**REGULAR MEETING OF THE PLANNING BOARD
WEDNESDAY, JULY 26, 2017
7:30 PM
CITY COMMISSION ROOM
151 MARTIN STREET, BIRMINGHAM**

**CITY OF BIRMINGHAM
PLANNING BOARD ACTION ITEMS
OF WEDNESDAY, JULY 12, 2017**

SUBJECT: 375 S. Eton – The District Lofts
Final Site Plan & Special Land Use Permit Review – District Lofts Building B

A.201
C

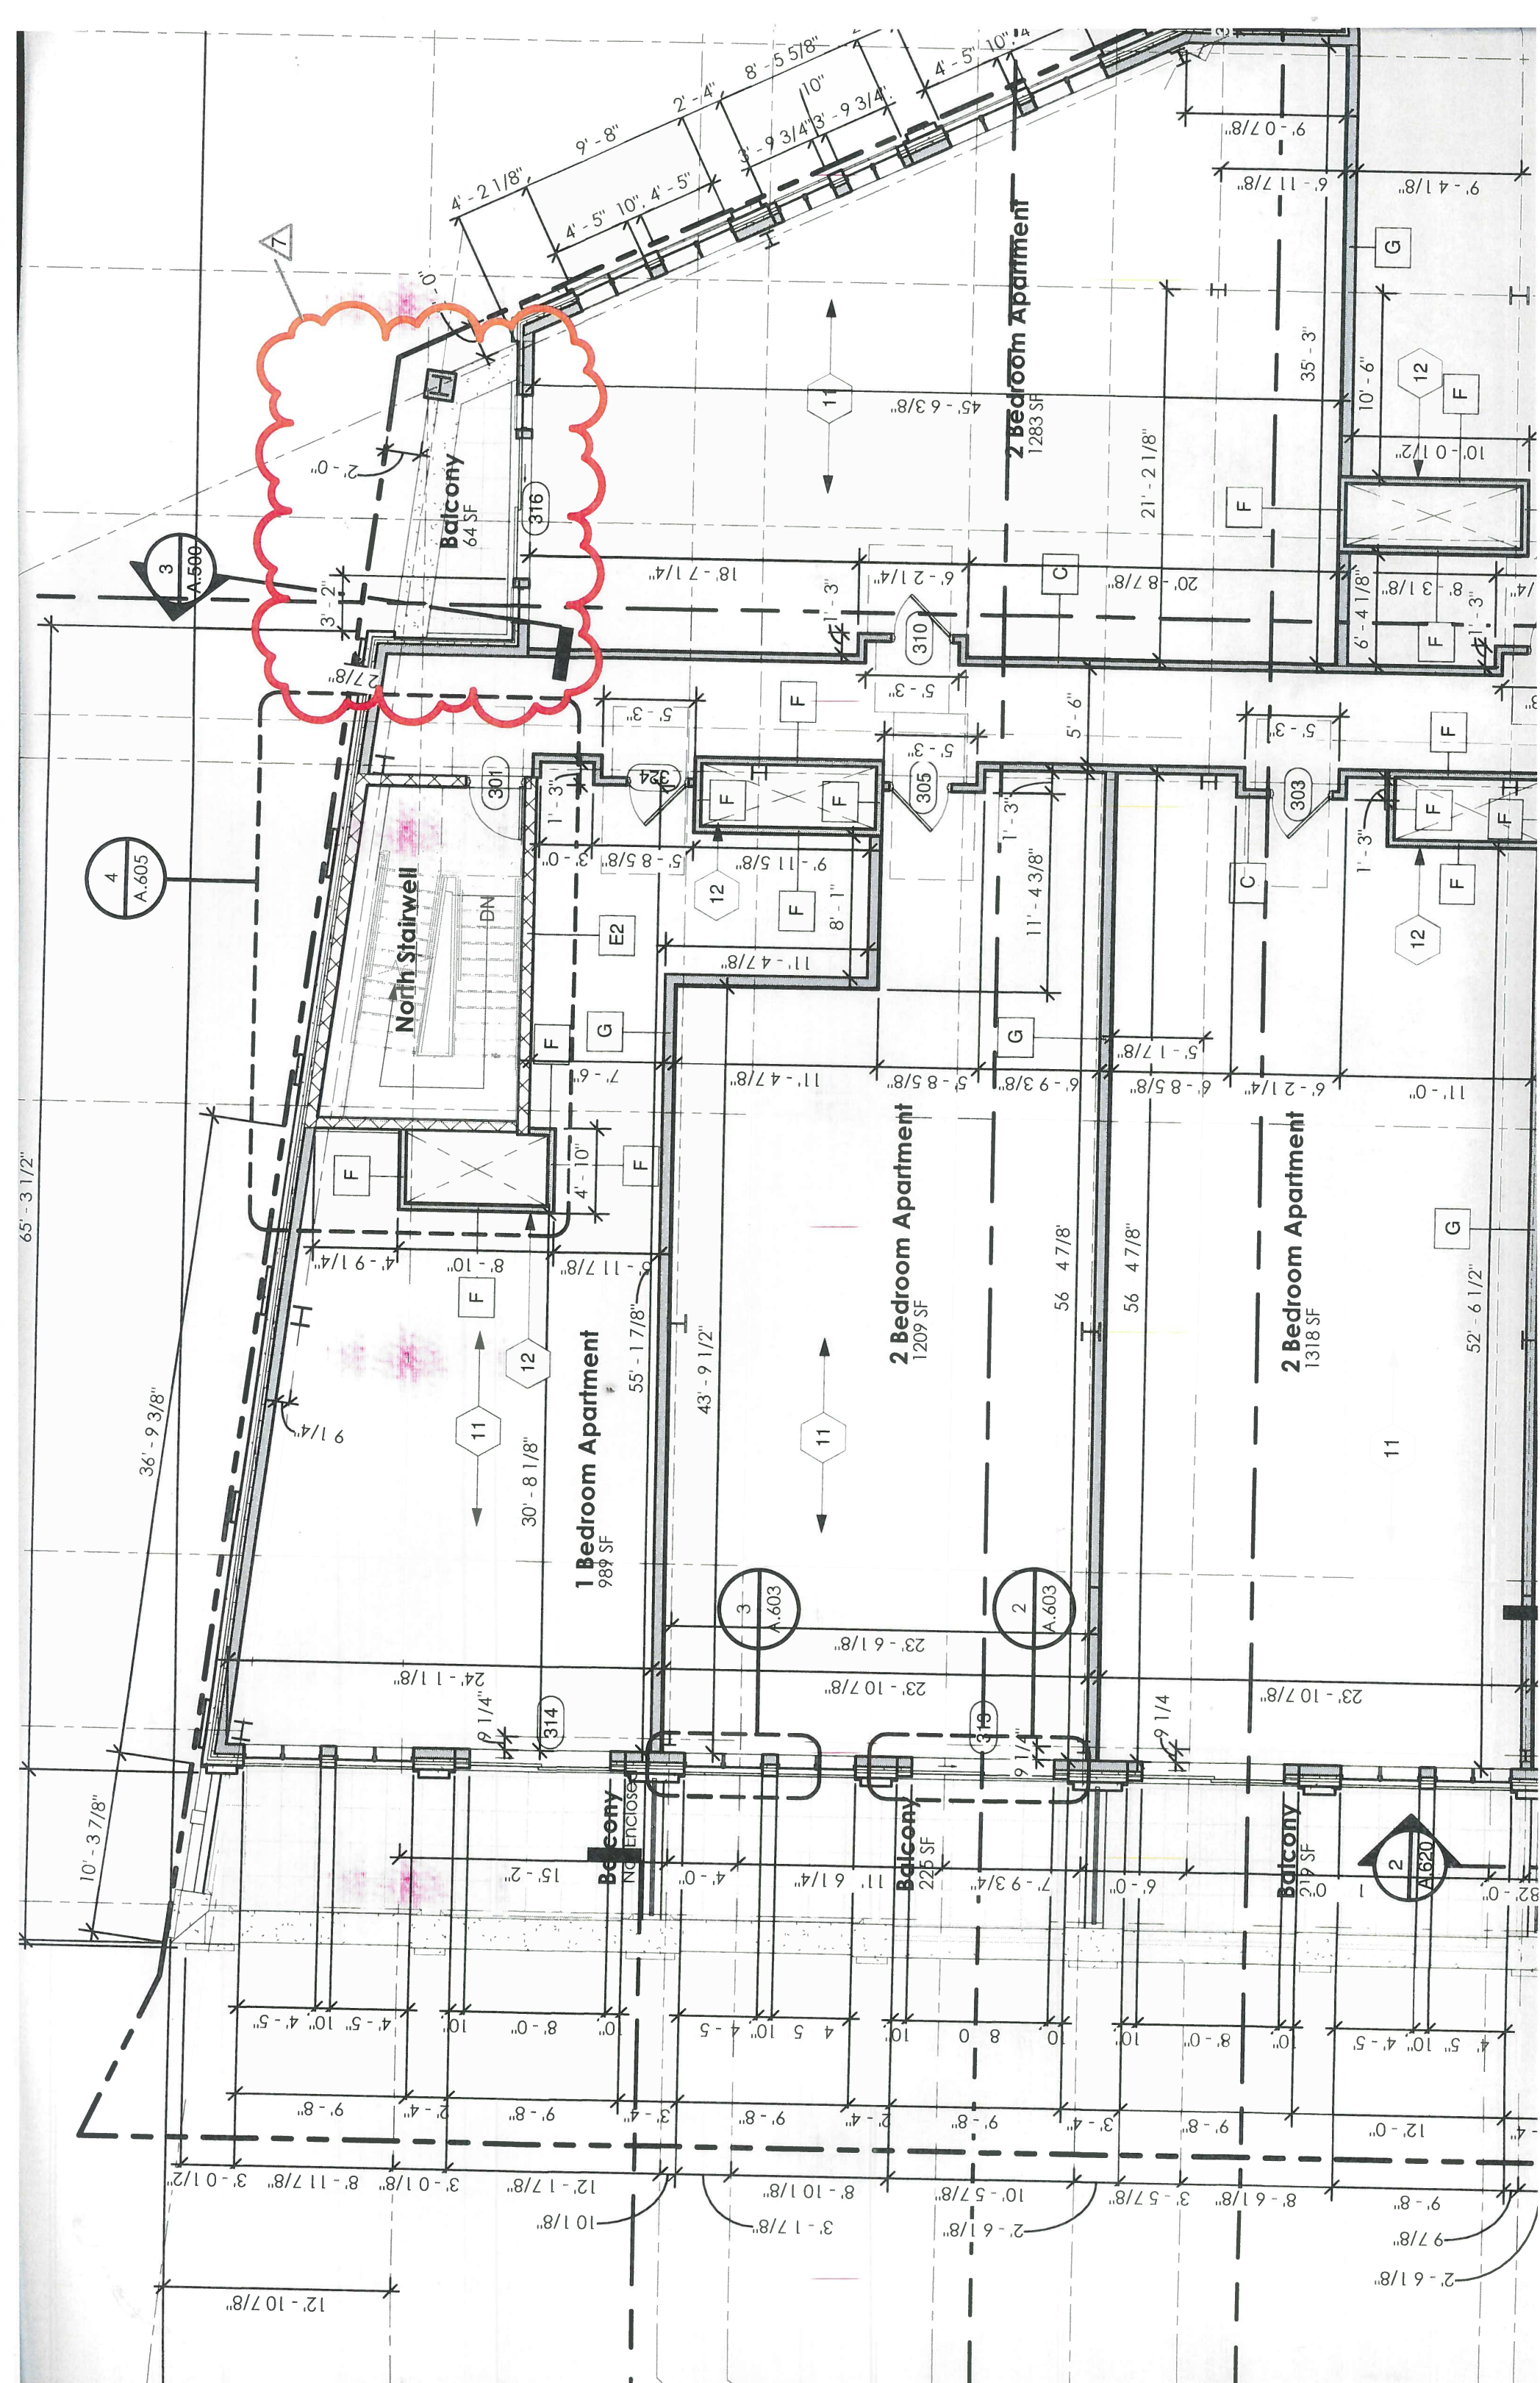
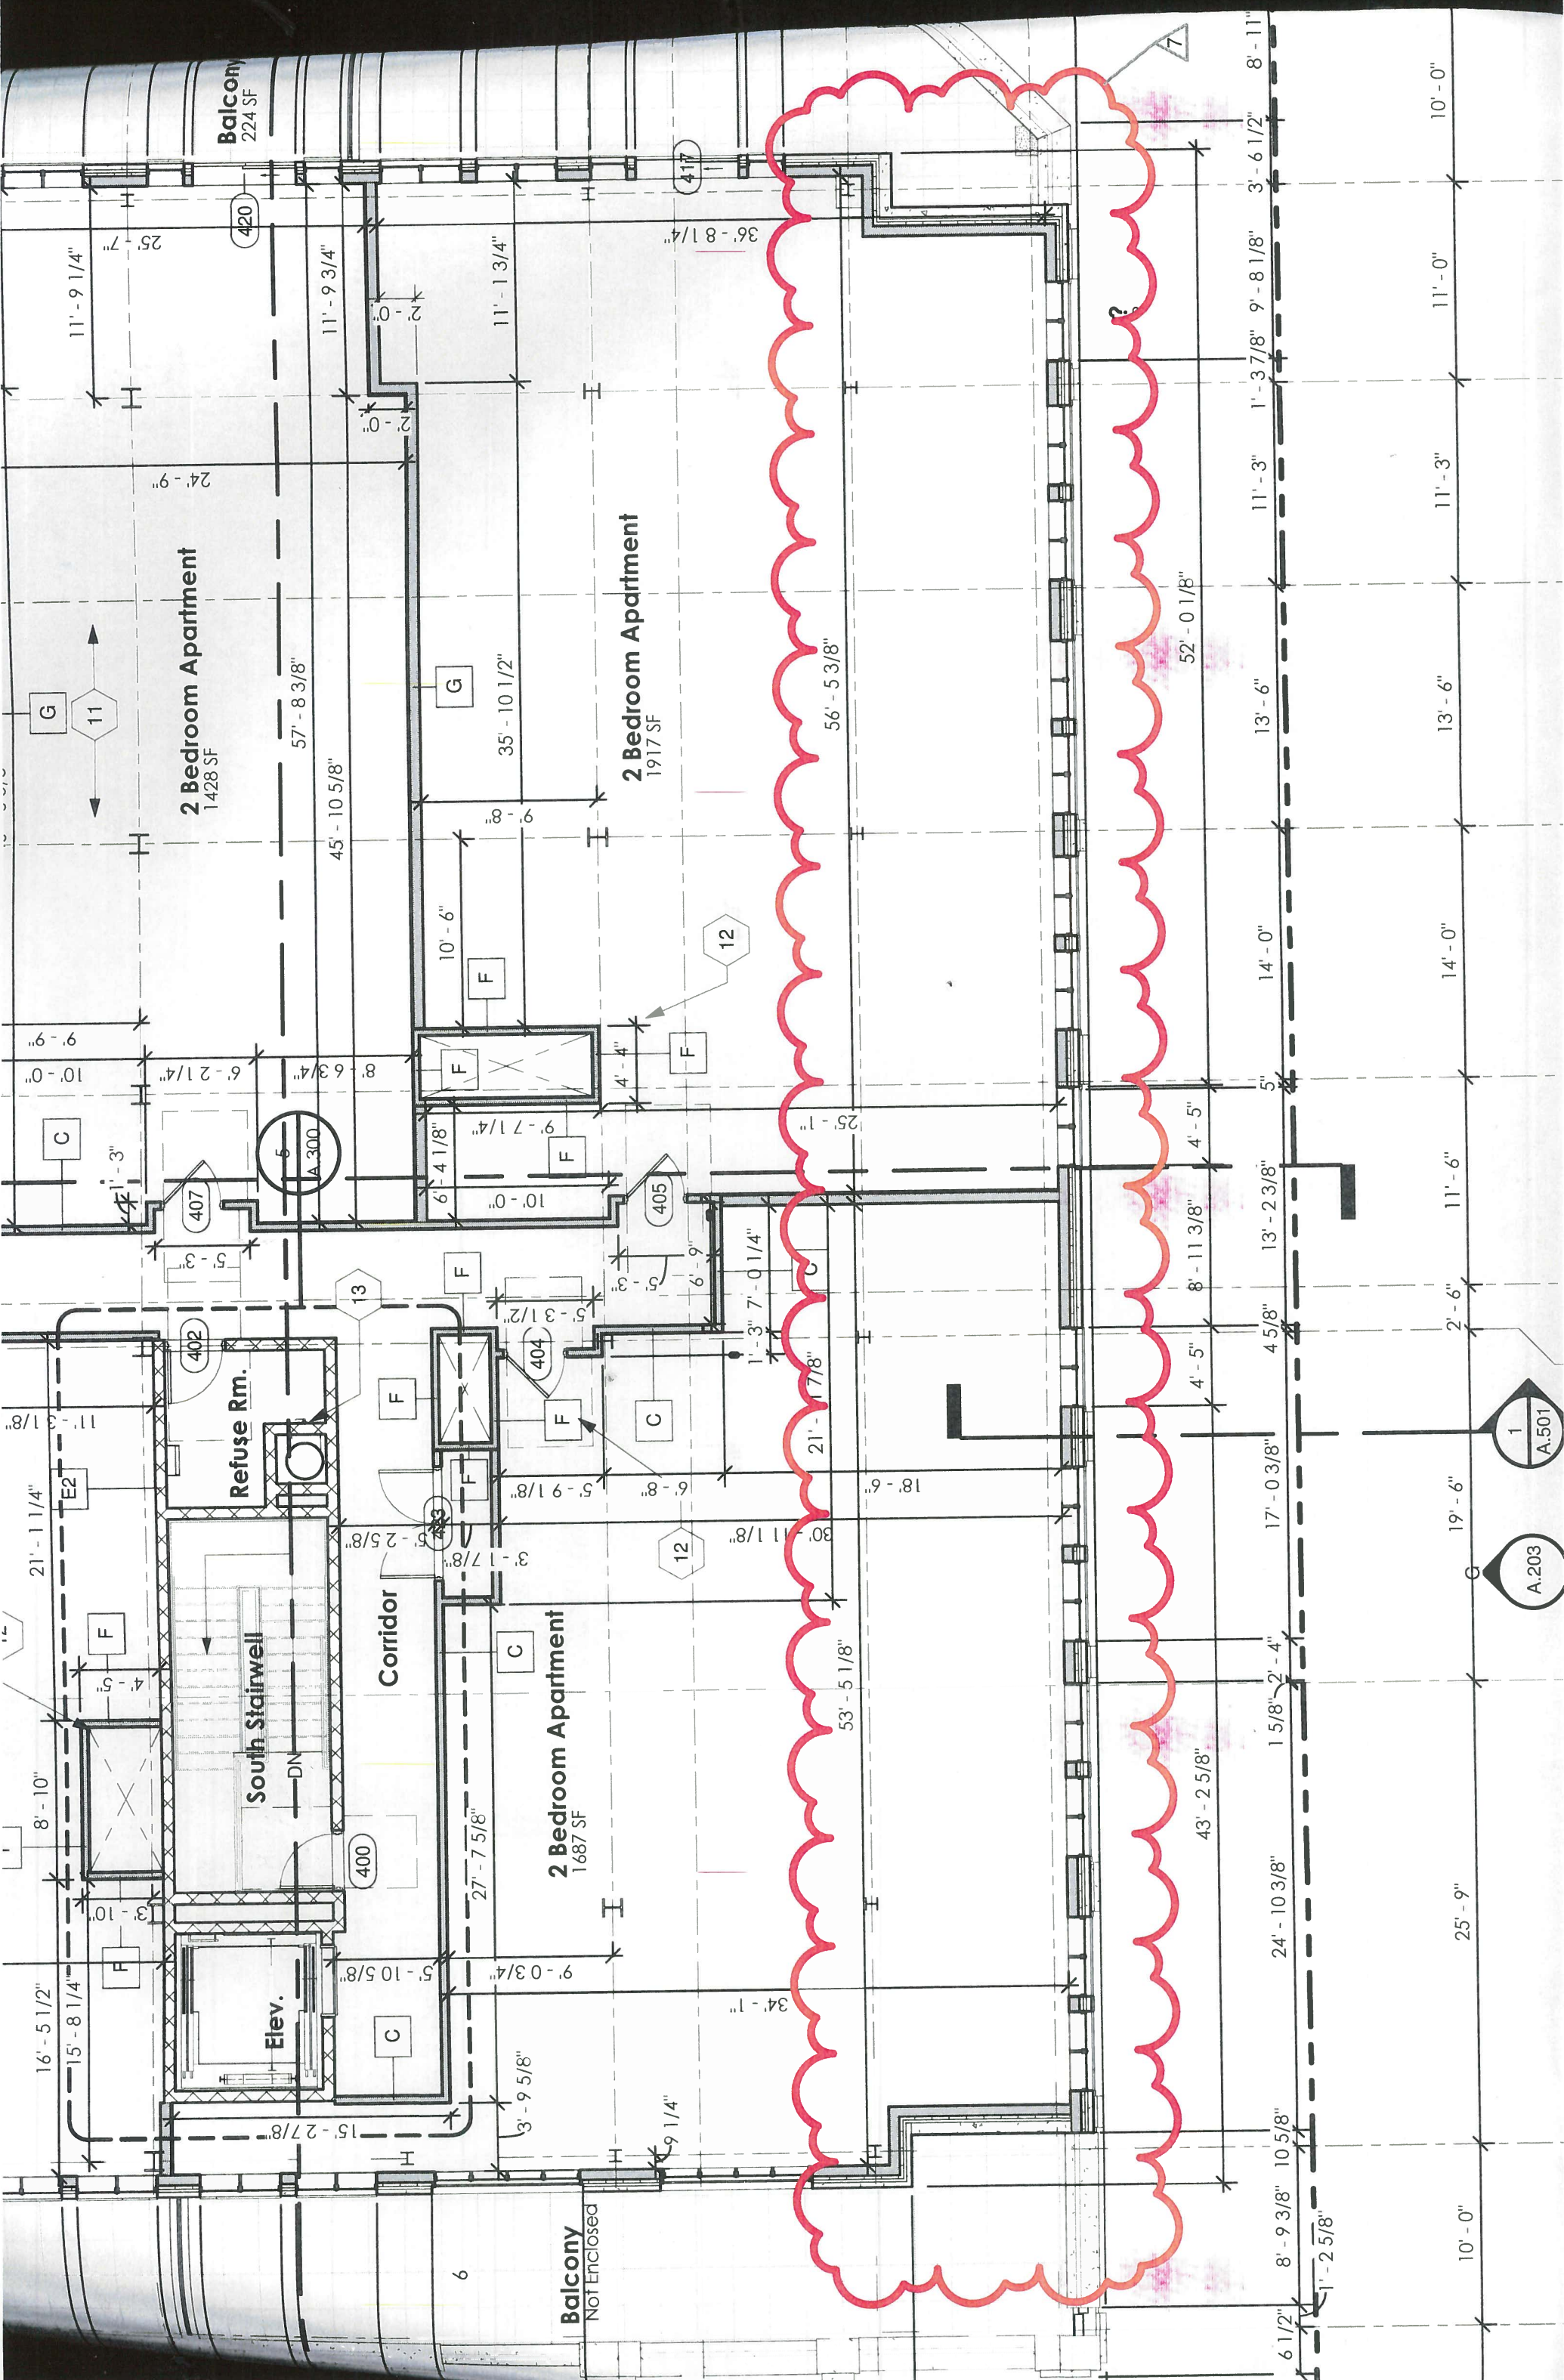
- The building plans show exterior work for the northeast elevation and north elevation at the patio. **The Planning Division cannot approve any of this work as the Final Site Plan does not demonstrate work on these portions of the North Elevation.** Request for administrative approval to allow exterior work on Northeast and North elevations at the patio. Sheet A.201

- The north elevation shows 4 unapproved "Residential Light Sconces." **The applicant will be required to obtain Administrative Approval for all proposed light fixtures.** Request for administrative approval for proposed lighting schedule and locations. Sheet A.201

- The right portion of the north elevation is almost completely devoid of windows and does not match the approved Final Site Plan. **The applicant must revise these drawings to demonstrate the proper calculation methods were used and that the glazing requirements continue to be met.**
Window and glazing calculations meet requirements for Downtown Birmingham Overlay District, Window standards for Zone B2B, and ICC 705.8 Allowable Openings for Exterior Walls. Sheet A.201

- The architectural component that runs vertically on the center of the elevation as shown in the approved Final Site Plan is completely devoid of any architectural accenting in the building plans. **The applicant will be required to obtain Administrative Approval for these changes.**
Request for administrative approval to remove architectural accenting from vertical component in center of elevation. Sheet A.201

- Request for administrative approval to reduce second story windows to 44 panes in 18 casements. Window and glazing calculations meet requirements for Downtown Birmingham Overlay District, Window standards for Zone B2B, and ICC 705.8 Allowable Openings for Exterior Walls. Sheet A.201
